**Comments and Proposed Alternative by Dan Johnson**  
**Albany Resident, Beach User, Bay Trail Commuter Cyclist**  
4/16/17

**Albany Beach Restoration and Public Access Project at Eastshore State Park – Phases 2 and 3**  
**BCDC Permit Number 2014.005.01**  
**Exhibit package dated 4/17/17**

BCDC DESIGN REVIEW BOARD: APRIL 17, 2017

## ALBANY BEACH RESTORATION AND PUBLIC ACCESS PROJECT: PHASES 2 & 3 AT MCLAUGHLIN EASTSHORE STATE PARK

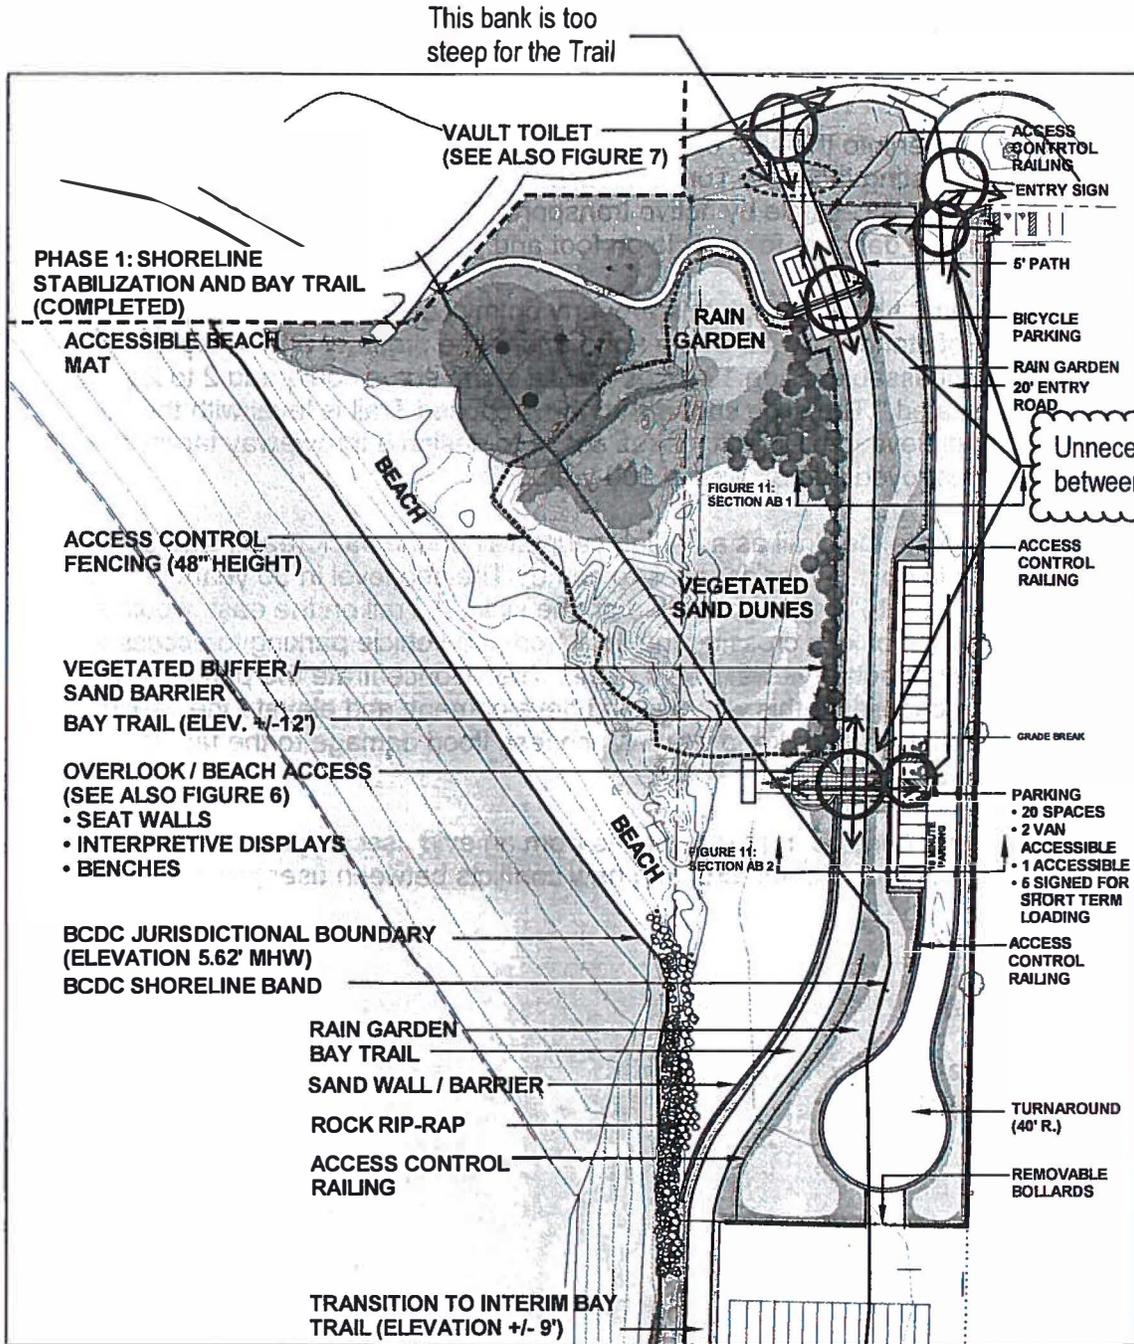
**8. Flood level.** I bike through this property on my commute to work. There is already 8" of standing water at the north end of the property after a big rain, making it impassable. Slide 19 notes that "a storm surge could add 2 to 2.5 feet to that indicated." The slide shows that the proposed Trail is level with the 2017 100-yr flood elevation. Does it make sense to design a throwaway facility that could be destroyed by next year's 100-yr flood?

Why not elevate the Trail as a 3'-high causeway on the back (east) side of the property, to keep it dry for decades to come? The sea level in 30 years is estimated to be 16" higher, as noted on the slide. A Trail on the east would also remove the risk of kids crossing the Trail from the vehicle parking to access the beach. You get better views from a higher Trail. Concentrate the parking on the north end, consolidate this with existing development, and elevate the parking area on 18"-24" of fill to keep it dry. Much less flood damage to the facilities for decades to come.

Figure 5

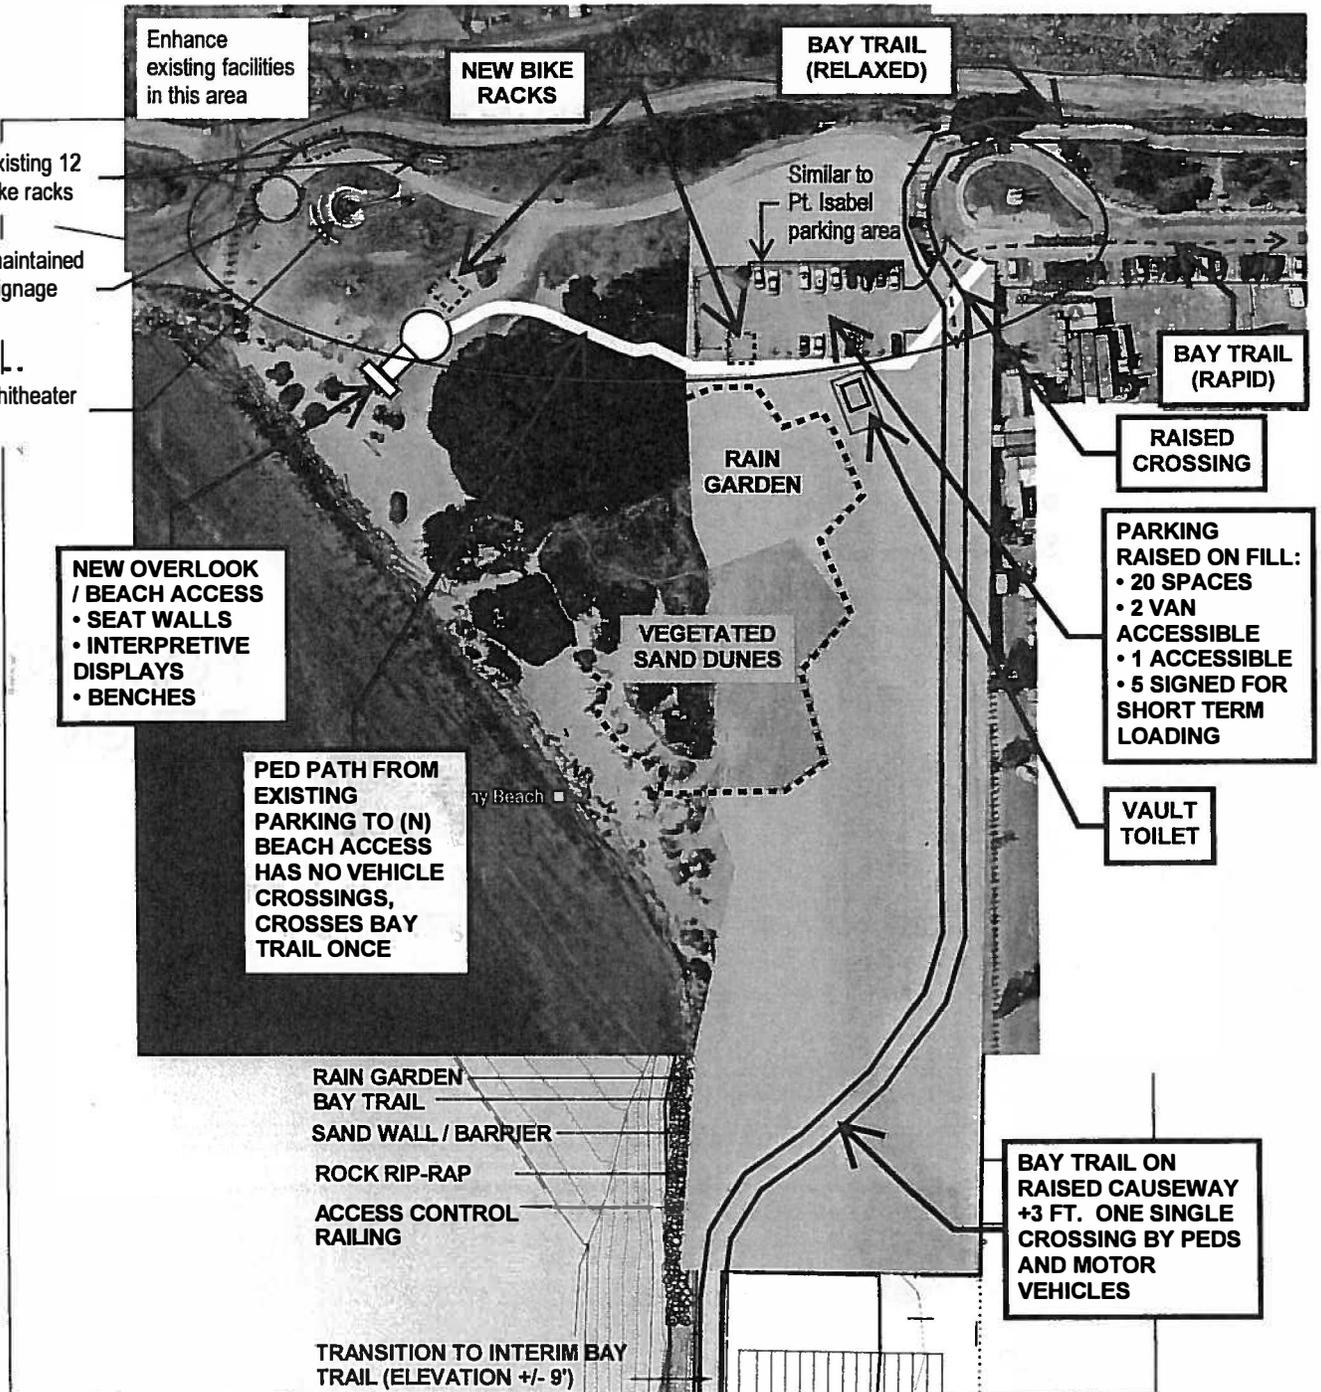
**1. Designers are creating unnecessary conflicts between users.** Please refer to annotated site plan, attached. These are unnecessary conflicts drawn into the current design:

- People who park vehicles have to cross the Trail to access the beach. Kids wander and don't look for cyclists. If a child is struck by a bike, it would be the fault of the design that brought them into conflict, and not the cyclist or child.

- Northbound cyclists have to circuit an out-of-the-way loop at the north end, before an unnecessary merge with northbound autos exiting the Entry Road at the existing roundabout.

- Trail cyclists coming west on Buchanan from Richmond who turn southbound onto the 20' Entry Road (as per current custom) become separated by fencing and have no way of rejoining the Trail without going through the handicapped parking area. Indeed, this is a shortcut compared to the maze-like north end of the Trail in this plan.

- The Entry Sign location misguides Trail cyclists and peds --- it's oriented to auto drivers using the new parking.
- Users walking from existing parking need to cross the Entry Road and Bay Trail to reach the facilities. Most motorized users of the new facilities will arrive on foot, pulling wagons or equipment from existing parking.

- If the Trail were east of the Entry Road & new parking instead of west of the road, it would un-do most of these conflicts that the designers have created.

Figure 5  
**ALBANY BEACH SITE PROGRAM**

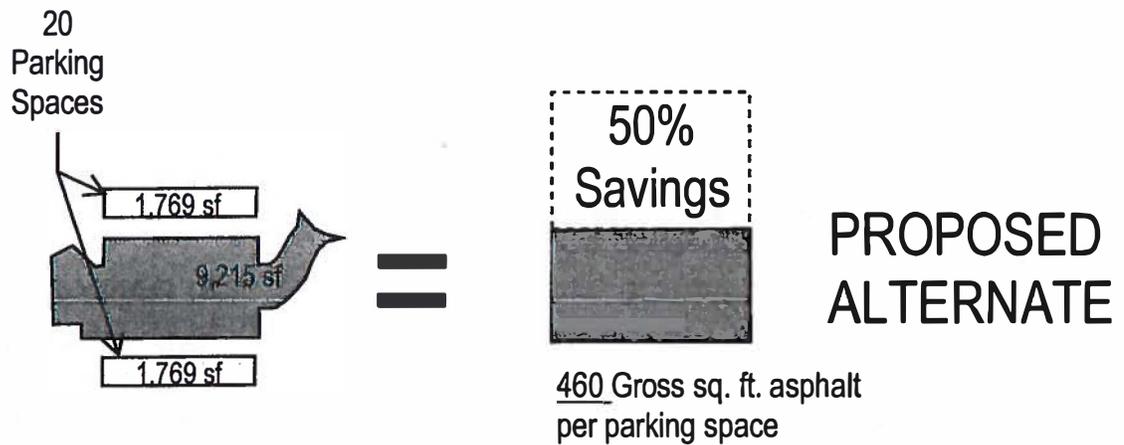
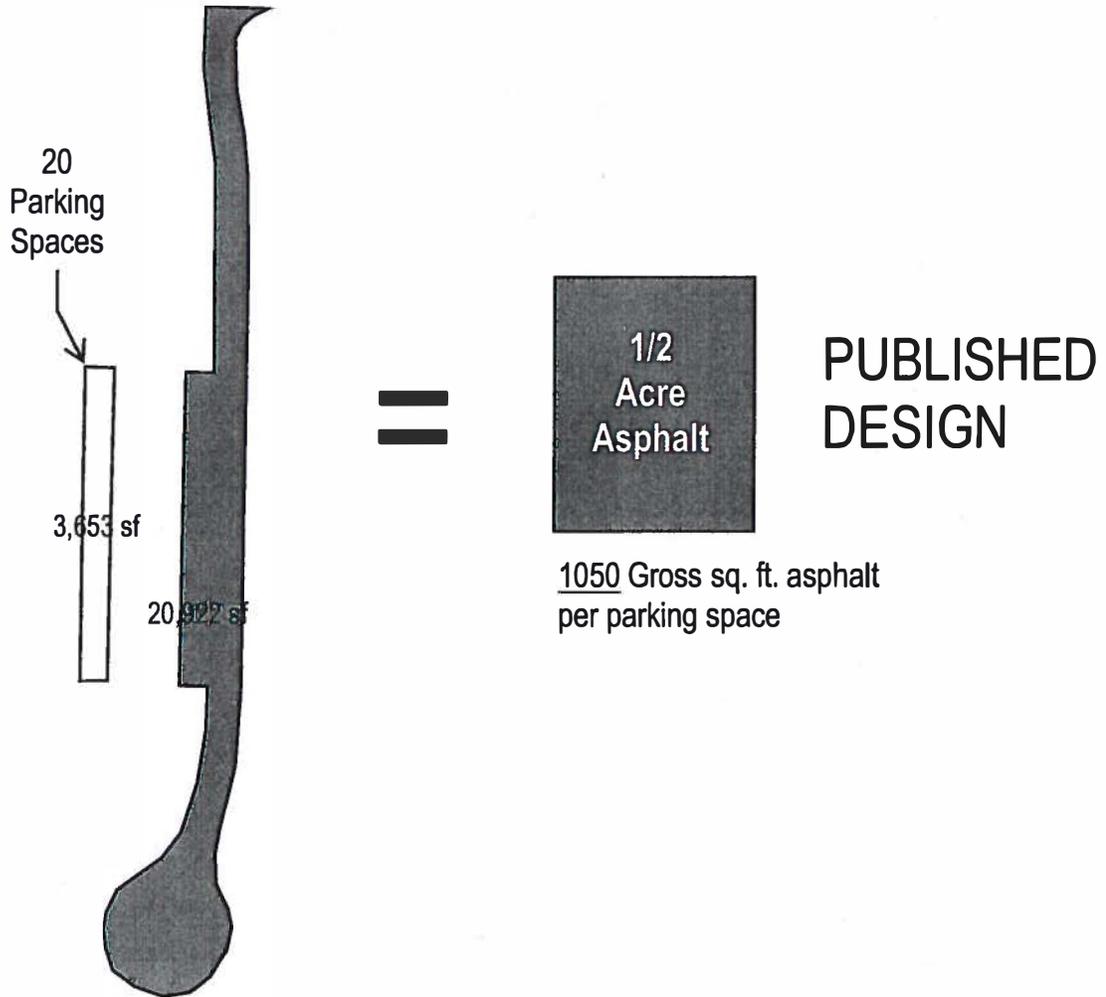
**5. Bay Trail "Relaxed" and "Rapid".** Please appreciate that there are at least two types of rider on the Bay Trail, the "relaxed" recreational riders and the "rapid" commuters. The rapid riders will try to avoid conflicts with slower users. The commuters currently ride on Buchanan rather than the Bay Trail in order to avoid conflicts with slower users. Please facilitate entry and exit from the new portions of the Bay Trail onto Buchanan, as well as continuity of the "relaxed" Trail. This is illustrated in the Proposed Alternate attached.

**6. Too much asphalt?** I'm measuring 20,700 sq.ft. of new asphalt being put down --- about 1/2 acre --- in order to provide 20 vehicle parking spaces (3,700 sq.ft). This seems like an inefficient use of resources. Please return this site to passive recreation and keep the asphalt and motor vehicles out. Could all the vehicle parking and turnaround be concentrated on the north end, **focused on consolidating and enhancing existing development**, to keep the remainder of the property unpaved? Might this also reduce the project cost as well as future maintenance costs? We can cut asphalt by 50%.

# TOO MUCH ASPHALT

**PROPOSED ALTERNATE**

Figure 5  
**ALBANY BEACH  
 SITE PROGRAM**

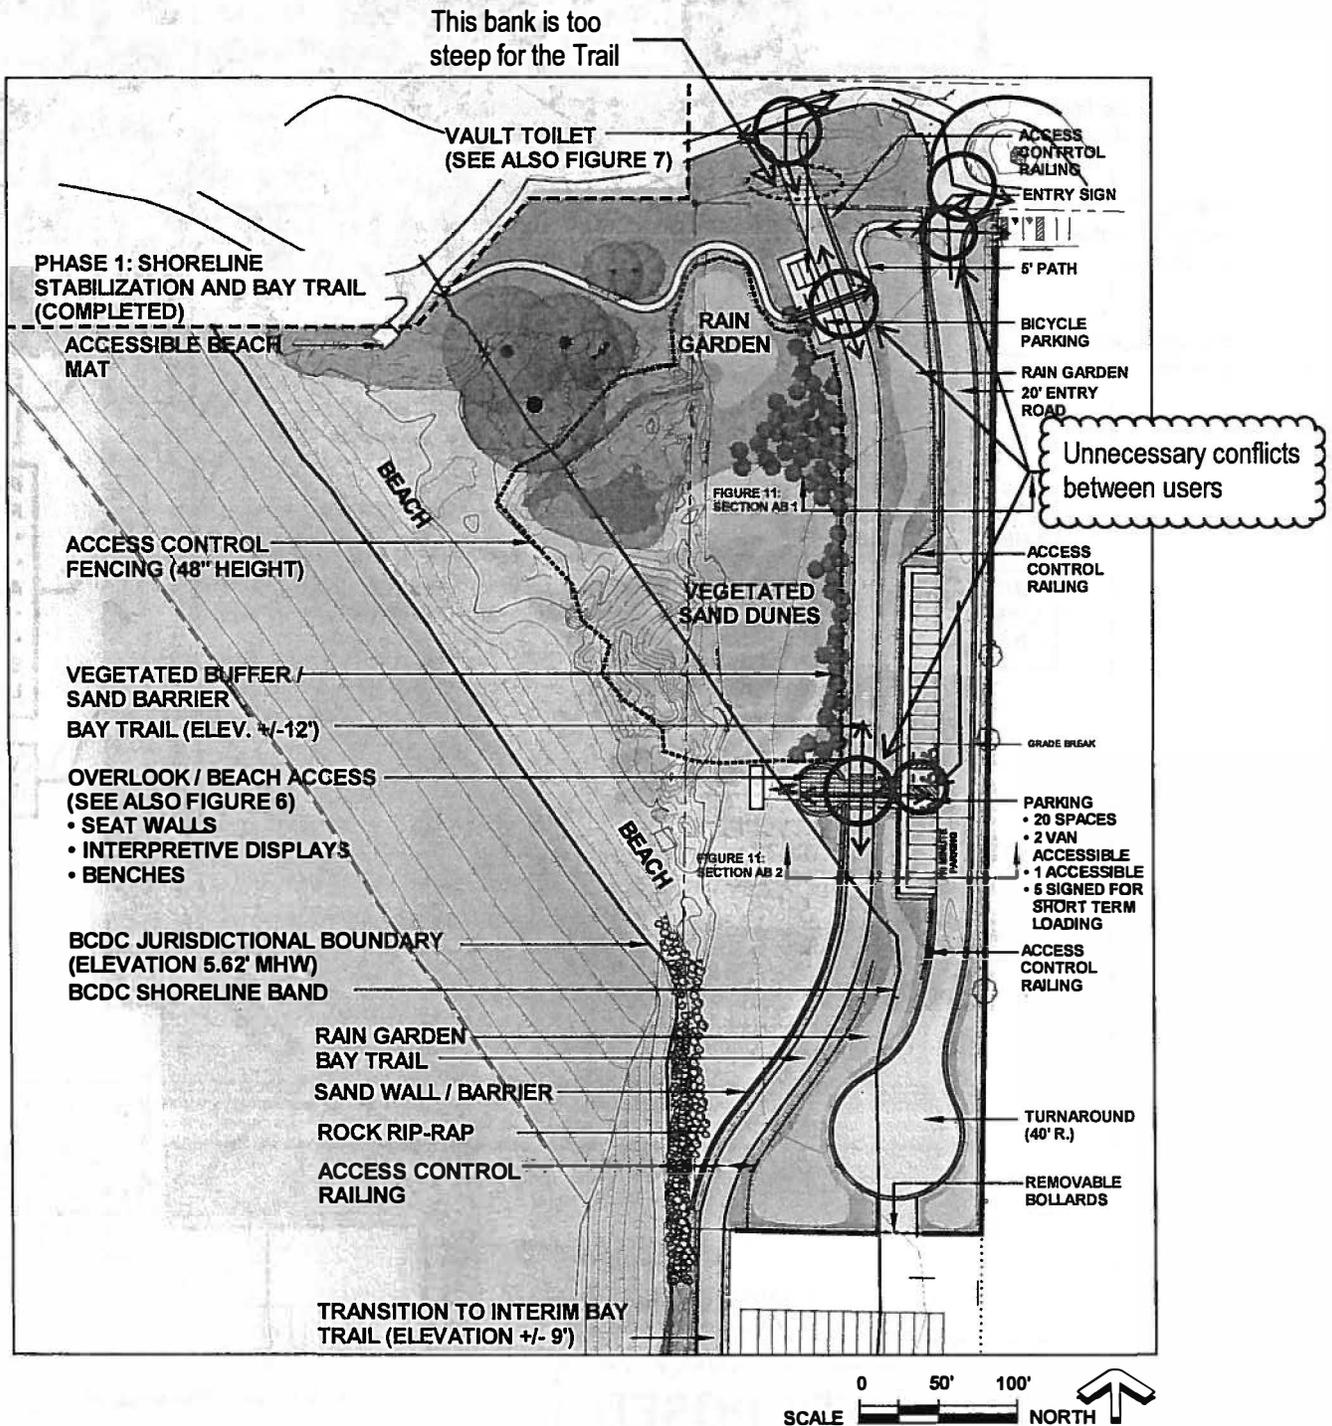
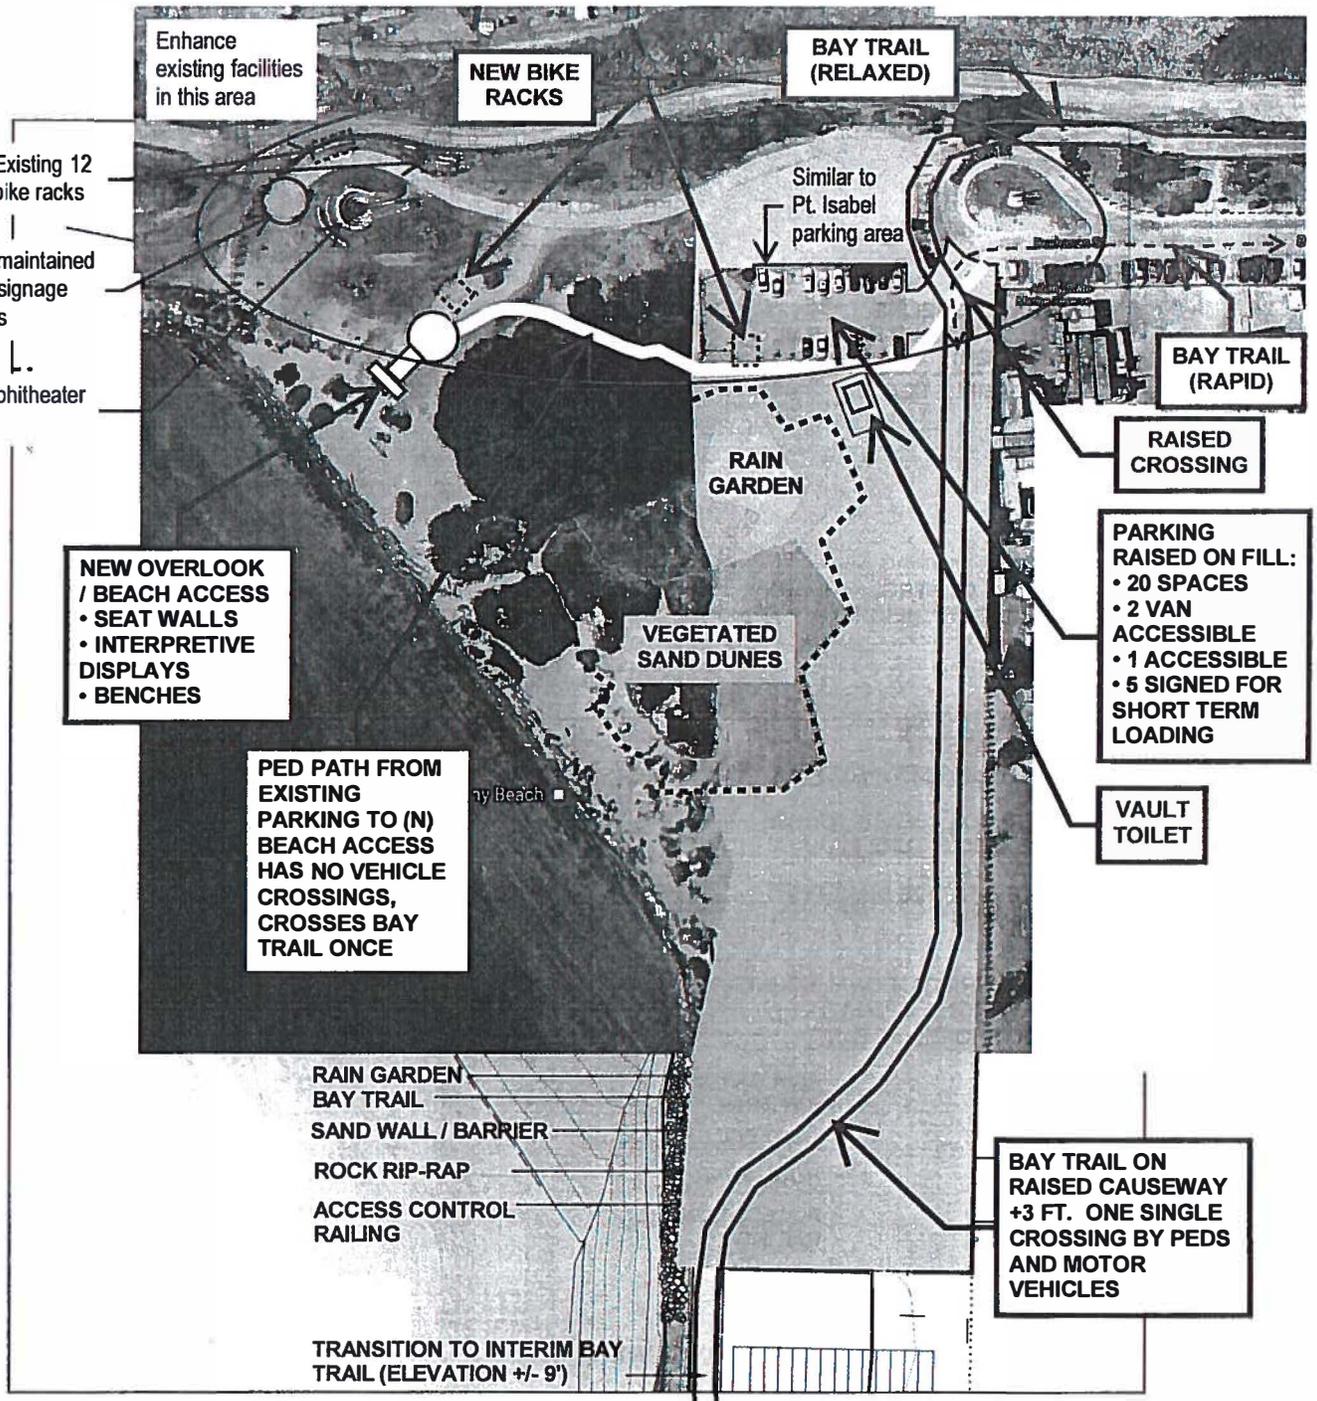
I am writing with suggestions that generally echo (and go beyond) ideas represented in the "Proposed Alternate" that Dan Johnson, Albany resident, has submitted along with his comments in his revision of Figure 5, Albany Beach Site Program (I am providing his sketches as a location guide to my comments).

1. Consolidate the parking at the north end of the site to reduce the amount of impermeable surface in the project and reduce conflicts among different users.

3. Leave the southern part of the site less developed with less impermeable surface, eliminating the long driveway and turnaround. (The huge racetrack parking lot provides plenty of emergency vehicle access.)

4. Locate the Bay Trail to the east of the parking so that people can go from their cars straight to the beach and trails to the Bulb and Plateau without creating collisions on the Bay Trail. In the current proposal, people carrying beach chairs, babies, kites, fishing coolers and wrangling dogs and kids across the Bay Trail could be a hazard.

5. Eliminate the pedestrian/bike traffic jam area at the north end of the current proposal that will result from channeling people from the narrow east-west portion of the existing trail to the new north-south portion. This spot near the bird sculpture turnaround is often filled with foot traffic, dogs, baby strollers, marathon-training tables, people meeting for group hikes, etc.

**PROPOSED  
ALTERNATE**
